Access Compliance Report

Public Rights-of-Way

(Curb Ramps)

Intersection ID: 50242	Main Street: BLAIREBETH_ST	Cross Street: CEDAR_WALK_LN	Location: SW
ADA ID: B857A0C8A4D4	Ramp Type: PerpDiag	Initial Pass/Fail: Fail	Overall Compliance: No
Severity Score: 37.5			
Codes/Mitigation Info/Possible Solution		Field Measurements/Component Compliance

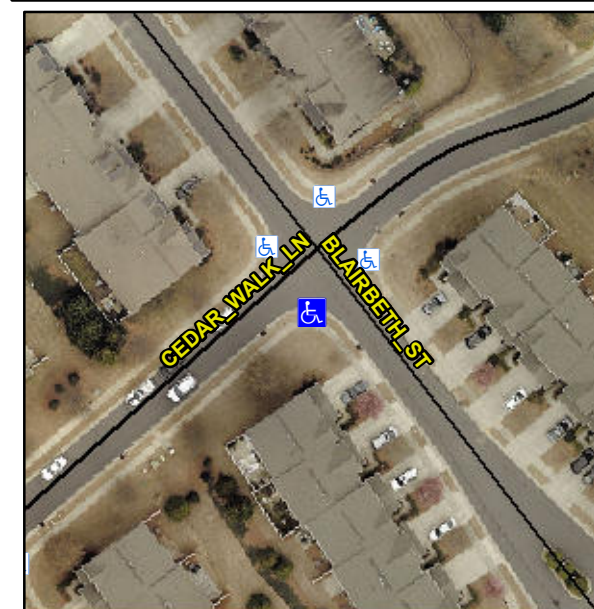
Not Found, R304.2.2, R304.5.3

Compliance	Description	Data	Compliance	Description	Data
N/A	Ramp Length (in)	46.0	No	Ramp Slope (%)	10.0
Yes	Ramp Width (in)	48.0	No	Ramp XSlope (%)	7.1
N/A	Flare Type LT	N/A	N/A	Flare Type RT	N/A
N/A	Flare Slope LT (%)	N/A	N/A	Flare Slope RT (%)	N/A
N/A	Flare Traversable LT?	N/A	N/A	Flare Traversable RT?	N/A
N/A	Landing Length (in)	N/A	N/A	DWS Provided?	N/A
N/A	Landing Width (in)	N/A	N/A	DWS Contrast?	N/A
N/A	Landing Slope (%)	N/A	N/A	DWS Length (in)	N/A
N/A	Landing X Slope (%)	N/A	N/A	DWS Full Width?	N/A
N/A	Landing Curb? (Y/N)	N/A	N/A	DWS Offset (in)	N/A
N/A	Shared Landing?	N/A			
N/A	Gutter Ponding?	N/A	N/A	Gutter Slope (%)	N/A
N/A	Gutter Lip Ht (in)	N/A	N/A	Gutter X Slope (%)	N/A
N/A	Painted X Walk1?	No	N/A	Painted X Walk2?	No
	X Walk 1 Direction	To NE		X Walk 2 Direction	To NW
N/A	X Walk 1 Width (in)	N/A	N/A	X Walk 2 Width (in)	N/A
	X Walk 1 Slope (%)	1.8		X Walk 2 Slope (%)	2.4
	X Walk 1 X Slope (%)	3.7		X Walk 2 X Slope (%)	5.2

Remove & Replace Curb Ramp With Two New Directional Ramps or Equivalent.
